Comments of Public Service Company of New Hampshire d/b/a Eversource Energy

EPA's Statement of Substantial New Questions for Public Comment on

Draft National Pollutant Discharge Elimination System Permit

Merrimack Station

Figure - *Corbicula Fluminea* in the United States

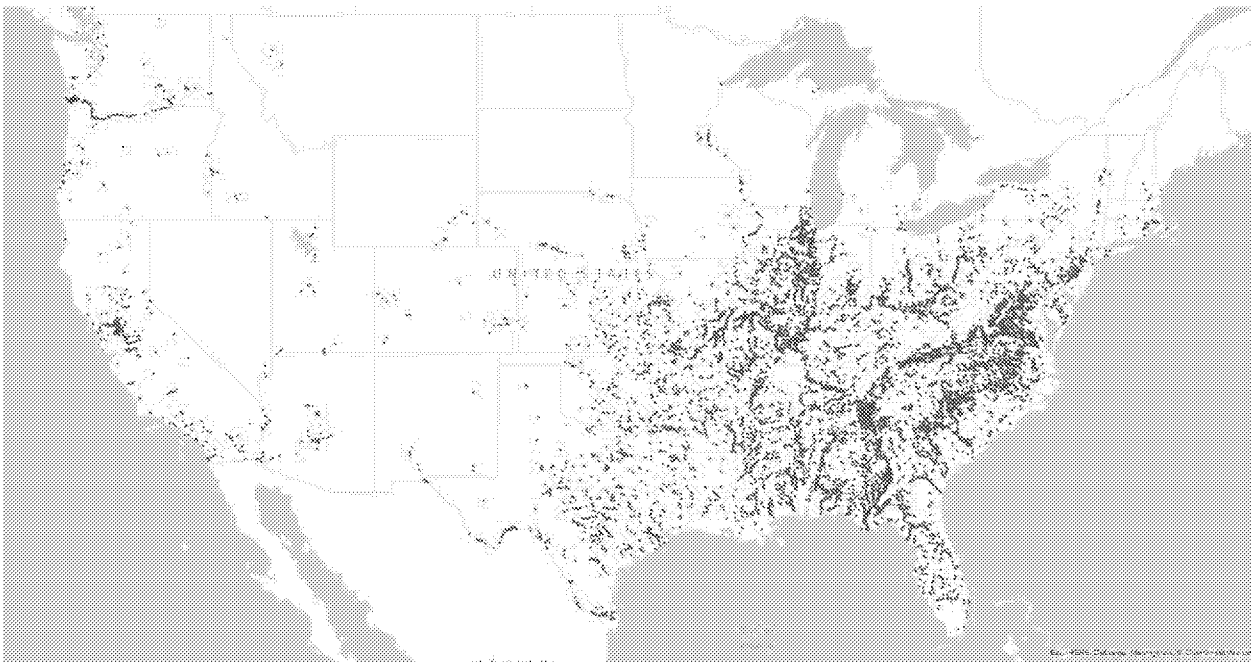
The Asian clam is ubiquitous, as the Statement notes,[281] and found throughout the United States near power plants and elsewhere. Asian clams are prolific up major waterways in the west (e.g., Columbia River, Sacramento Delta region), up the Mississippi and Ohio Rivers and their watersheds, and along the east coast in major harbors, rivers, and their various tributaries. The figure below shows the extent of the Asian clam's presence in the United States:

Figure - Overlay of Power Plants and Findings of *Corbicula Fluminea*[283]

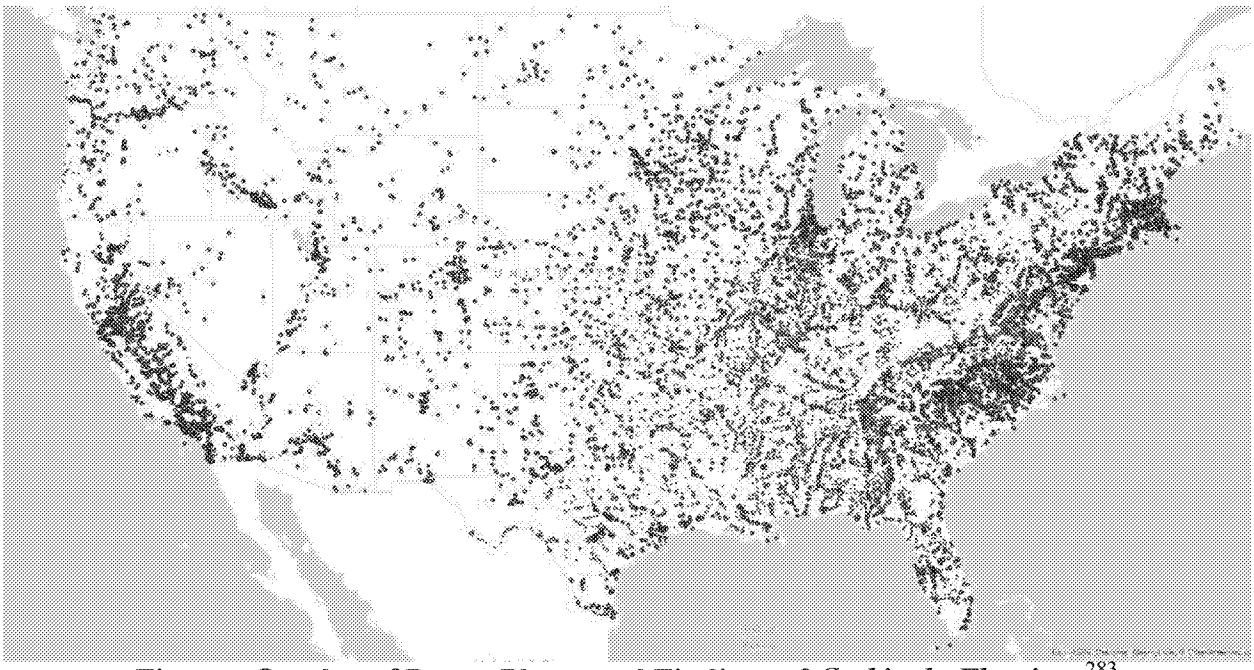
The red dots shown on the map represent Asian clam locations reported in the United States Geological Survey (USGS) database.[282] Further, the Asian clam is extensively found near power plants (shown in green):

Given EPA's silence concerning the Asian clam despite receiving the findings of Normandeau that Hooksett Pool hosts a healthy, BIP of fish and macroinvertebrates, PSNH did not anticipate EPA's interest in the Asian clam until learning of it by happenstance approximately three years ago. In 2014, PSNH observed EPA conducting dives, unannounced, with NHDES in the immediate vicinity of Merrimack Station. Near this same time period, EPA responded to several Freedom of Information Act ("FOIA") requests issued by PSNH concerning
